Remarks

The following remarks are responsive to the Office Action dated July 15, 2004. Applicants respectfully request the Examiner's reconsideration of the present application as amended.

ATM-262

ANNOTATED MARKED-UP DRAWINGS

Fig._ 2A

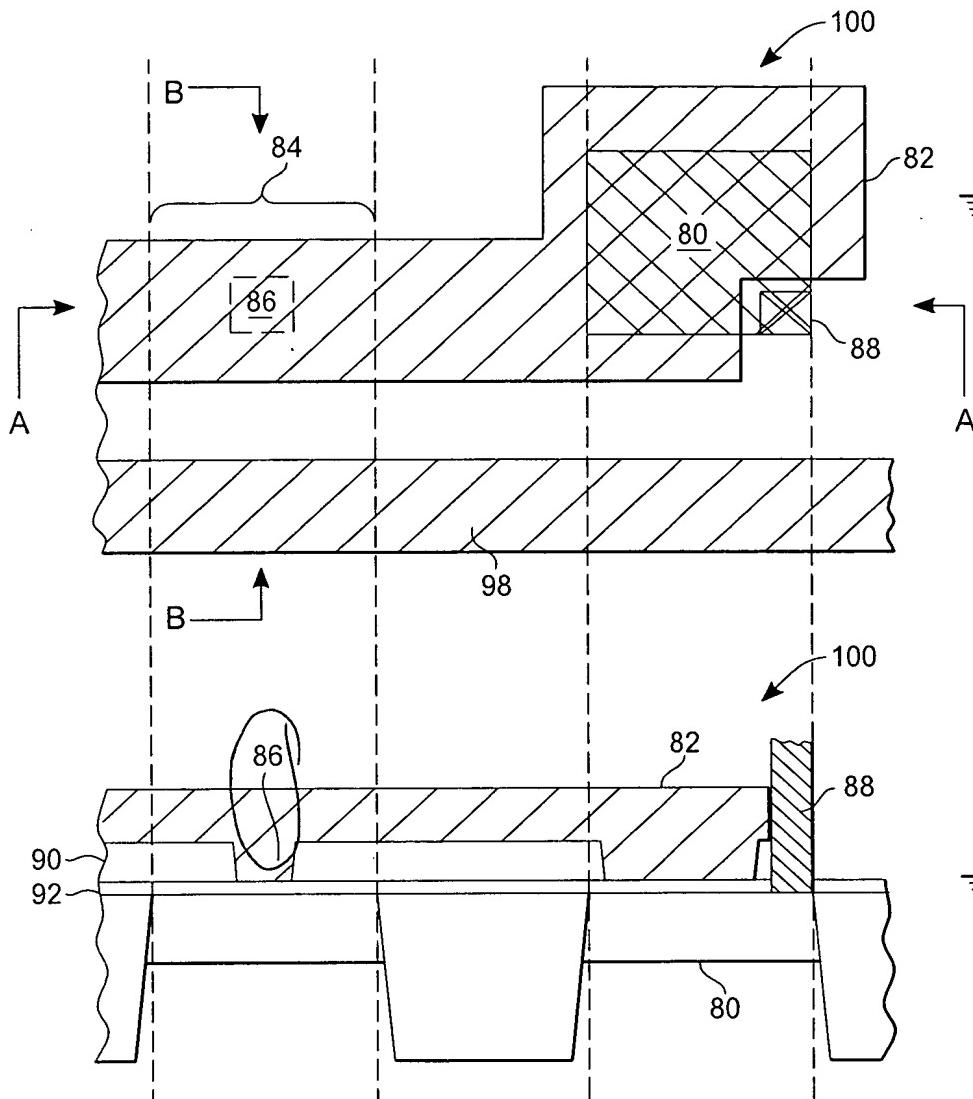
Figure 2B has been amended to improve clarity.

Fig._ 2C

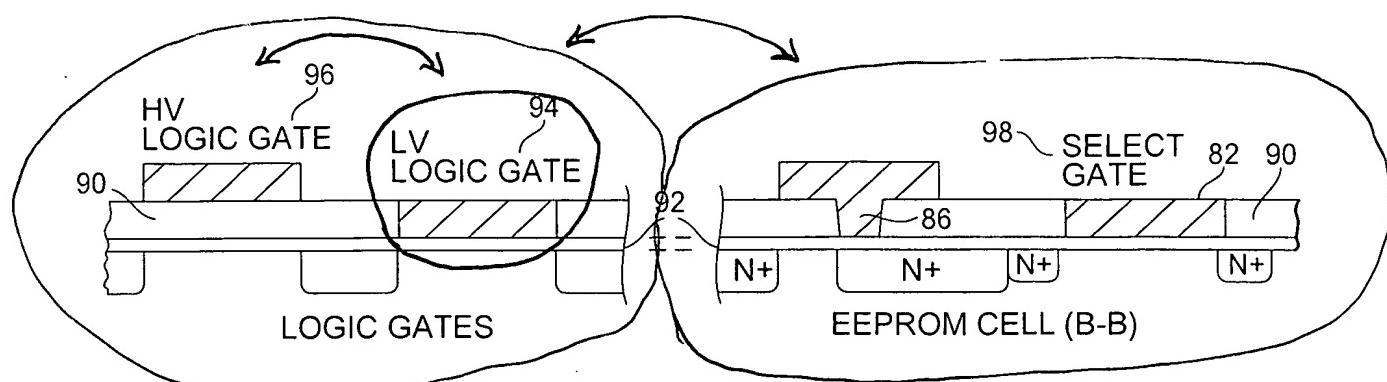
Figure 2C has been amended to improve consistency with the drawings in Figures 3A and 3B. The LOGIC GATES and EEPROM CELL drawings in Figure 2C have been switched or reversed to better correspond with the cross-sectional views presented in Figures 3A and 3B. In addition, the select gate in Figure 2C has been amended to correspond to the drawings in Figures 3A and 3B. No new matter has been added.
